SERVICE BULLETIN

REPLACEMENT OF WASHER PART NO. 944072 (FLY WHEEL HUB) FOR ROTAX® ENGINE TYPE 912 AND 914 (SERIES)

SB-912-058UL

SB-914-041UL

Fig. 1

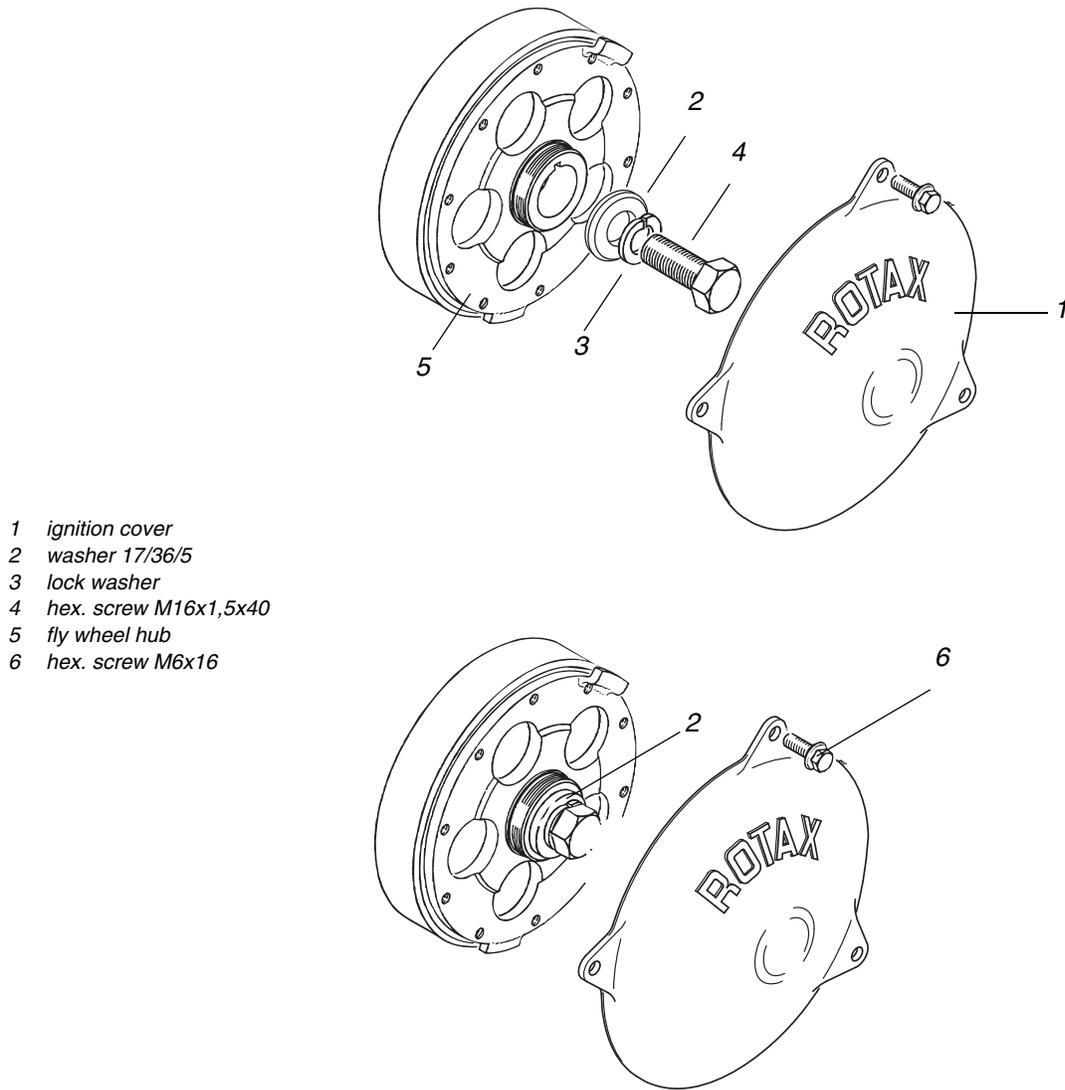
A deviation in hardening process could cause an exceeding of hardness of certain washer. This deviation could lead to cracks in the washer and could cause loosening of fly wheel, ignition failure or engine damage.

3.1) Replacement of washer part no. 944072

1. Remove ignition cover (1).
2. Lock the crankshaft in accordance with the relevant Maintenance Manual (Line).
3. Remove hex. screw (4) in accordance with the relevant Maintenance Manual (Heavy).

■ CAUTION: If the fly wheel hub has loosened during the disassembly and/or in case of doubt, then remove, clean and install the fly wheel hub in accordance with the relevant Maintenance Manual. In this case the tightening torque is 45 Nm (33.2 ft.lb) + 180° angle to rotation.

4. Install hex. screw (4). **Tightening torque 120 Nm (89 ft.lb).**

■ CAUTION: During installation the new washer (2) part no. 944072 must be used.

5. Remove locking pin of crankshaft in accordance with the relevant Maintenance Manual.
6. Check trigger coil gap, if necessary adjust it in accordance with the relevant Maintenance Manual.
7. Install ignition cover (1). The hex. screws (6) are locked with Loctite 221. Tightening torque 5 Nm (44 in. lb.).
